**AAFC Research and Development Centre
Outbuildings Renovations, St. John's, NL**

EA003-212073/A

**AMENDMENT # 3
ADDENDUM NO. 3**

1. Reference attached sketches SKM-01, SKM-02, SKM-03:

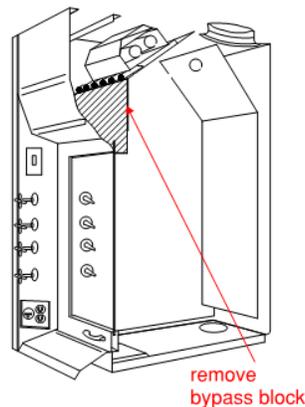
1. **Mechanical contractor** to provide an additional fan installation (EF-3) and associated chemical vent piping for the chemical storage cabinets at each fume hood as outlined.
2. **Electrical contractor** to provide power for the additional fan (EF-3) and wire as per M+E schedule c/w HOA starter
3. **Controls contractor** to provide start/stop and status control points.
4. **General contractor** to provide an additional mounting bracket and supports for EF-3 as per EF-1 and EF-2
